ADDENDUM NUMBER THREE

**T C ROBERSON HIGH SCHOOL CAFETERIA, PEP, AND POOL ROOF
REPLACEMENTS BUNCOMBE COUNTY SCHOOLS
RFP 12-16**

MLA PROJECT NUMBER:
16001

DATE OF ISSUE: April 29, 2016

CAFETERIA ROOF PLAN
SCALE: 1/8" = 1'-0"

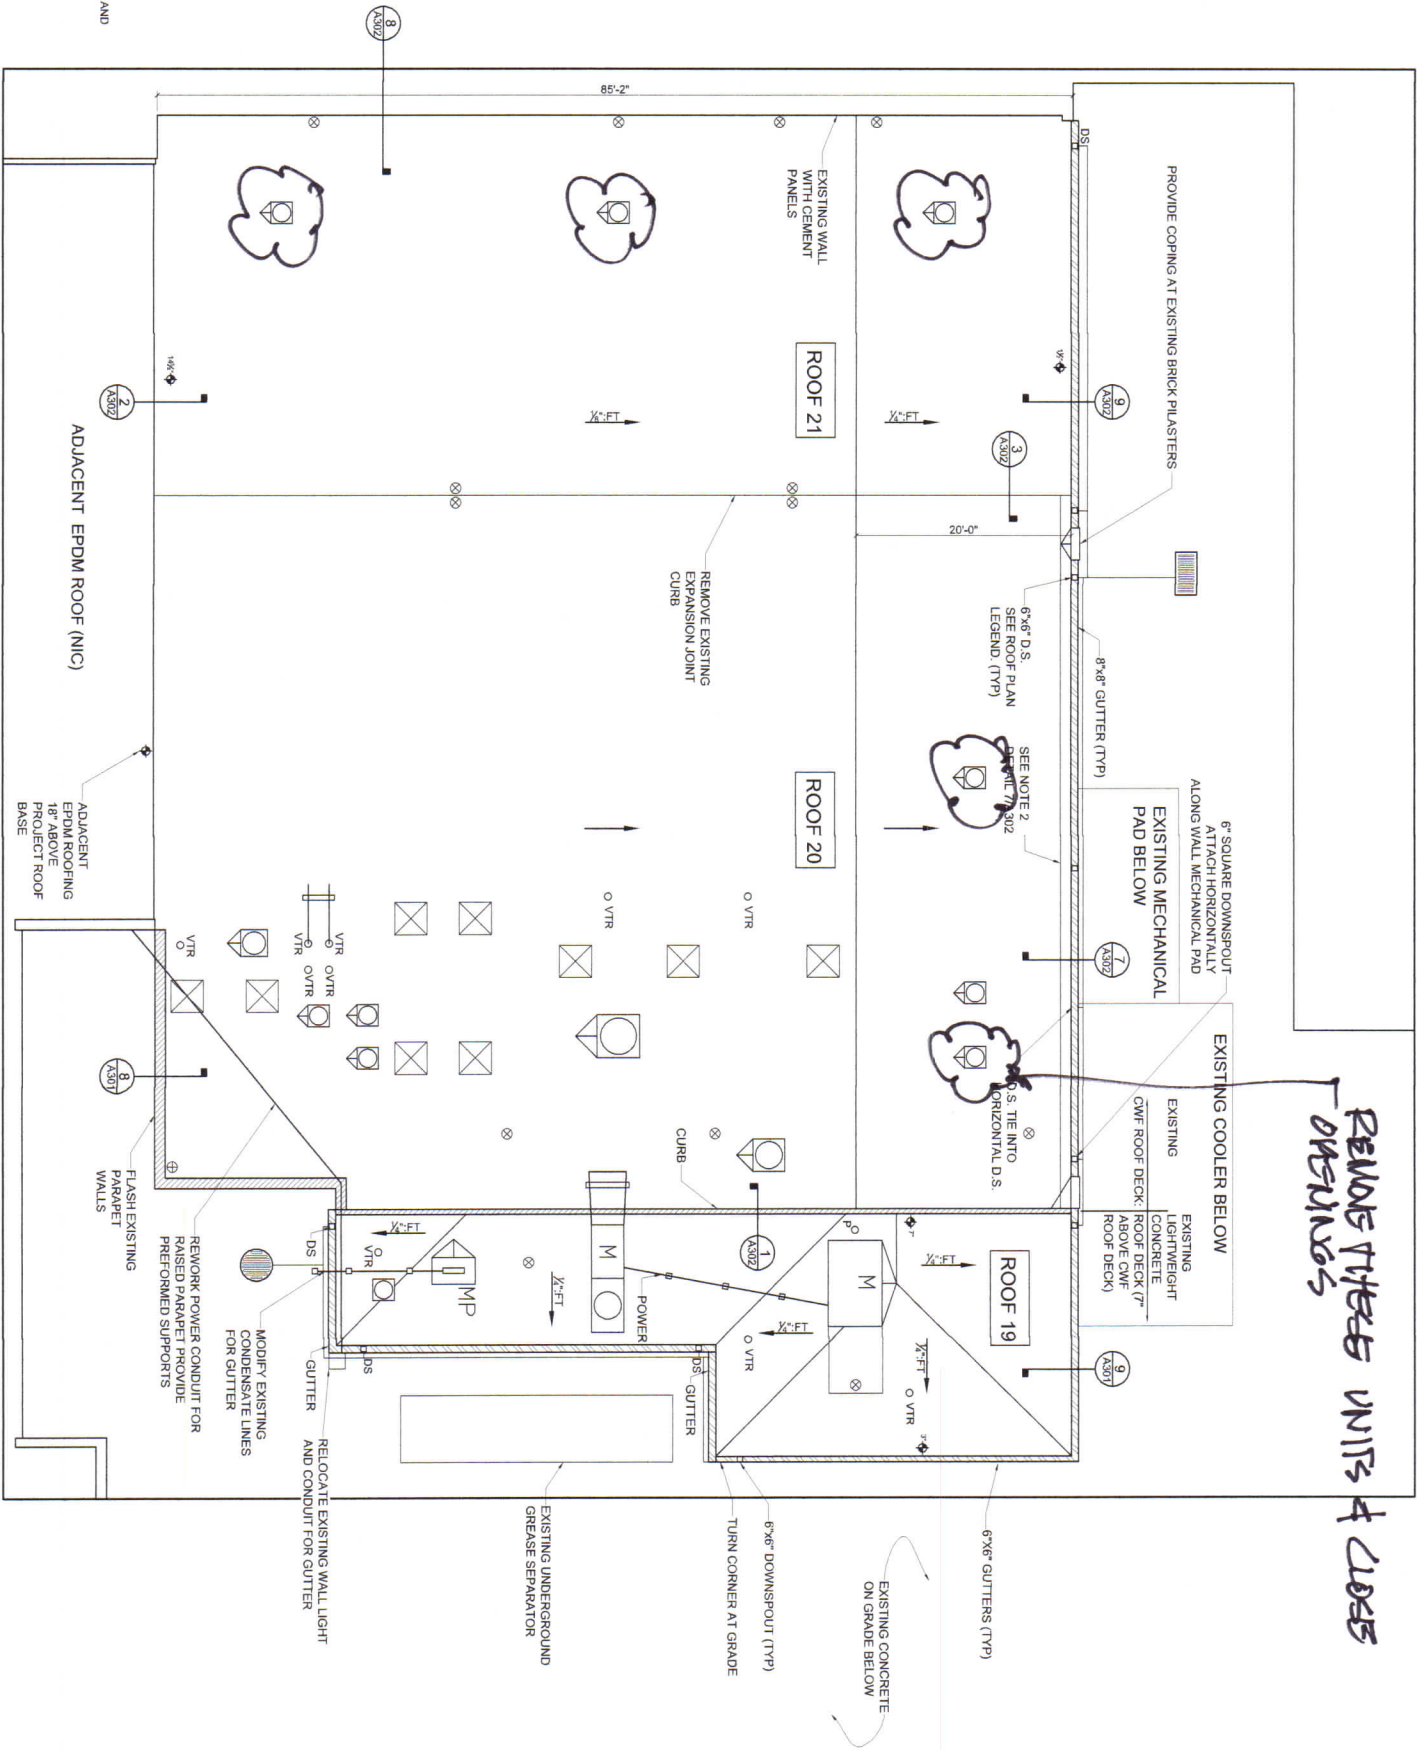
Attached is the correct drawing of A201A.
